19th September 2021

## Response to Consultation on Main Modification to EFDC Local Plan – South Epping Master Plan (SEMPA)

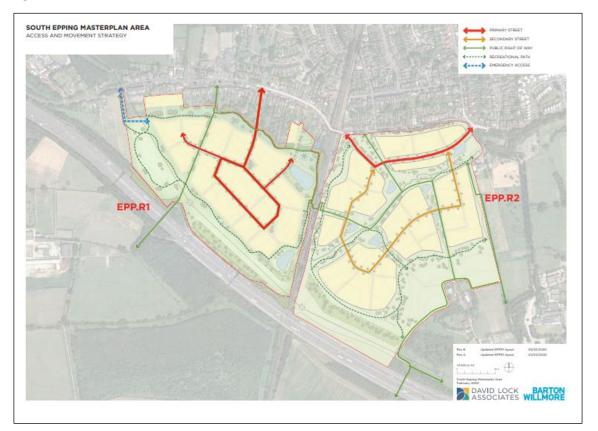
In fact it is clear that transport and access does not appear to have been considered at all. As noted above the inspector raised a concern that the 'essential' road bridge over the railway is a key consideration. The response appears to have been to remove the vehicle bridge and inclusion of the following statement within the Capacity Analysis:-

'There are no strategic transportation benefits in seeking to link EPP.R1 and EPP.R2 with a vehicular road bridge. A vehicular road bridge in this location would have the effect of attracting extra traffic to the south of Epping creating problems in the wider strategic flow of traffic distribution. A vehicular bridge through the site has the potential of creating a 'rat run' through the site.'

I am not sure what this statement is actually saying as the only additional traffic that will be attracted to the area would be vehicles related to the new development.

It would appear that the point of the bridge has been missed entirely. It is required to make the masterplan work, but its inclusion makes the masterplan un viable due to the significant cost of the bridge.

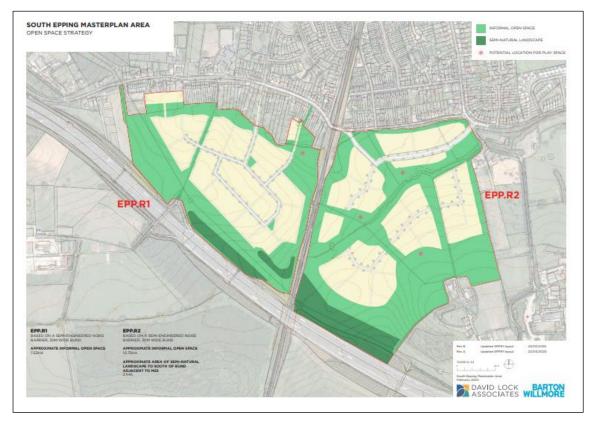
THE Capacity plan that has been published, which we assume is in support of the revised statement on removing the railway bridge has serious concerns relating to traffic. DLA confirmed that access and egress from the two land parcels had not been considered in detail during the preparation of the capacity analysis, and the routing shown in the access and movement strategy, shown above, has no technical back up, a fact I find astounding! How can capacity of a land parcel be considered if there is no viable traffic strategy. To say that transport will be considered at a later stage in the process seems to be too late and means that the viability of the site is just 'kicked down the road'.

EPR.R1 has one point of primary access and egress which is entirely reliant on a number of existing properties of Ivy Chimneys Road being demolished. I note these properties were not in the original plan to include these parcels in the plan. This would create a further congestion point in an area of Ivy Chimneys Road, which is already a nightmare due to the location of the primary school, narrow roads and parking. It is not clear how traffic will then move away from this area, Ivy Chimneys Road and the Bell Common junctions are already at capacity, to send traffic up Centre Drive would then add capacity issues to other junctions in the area.

EPR.R2 – the suggestion that there could be an access/egress point adjacent to the existing rail bridge in Bridge Road is beyond belief!
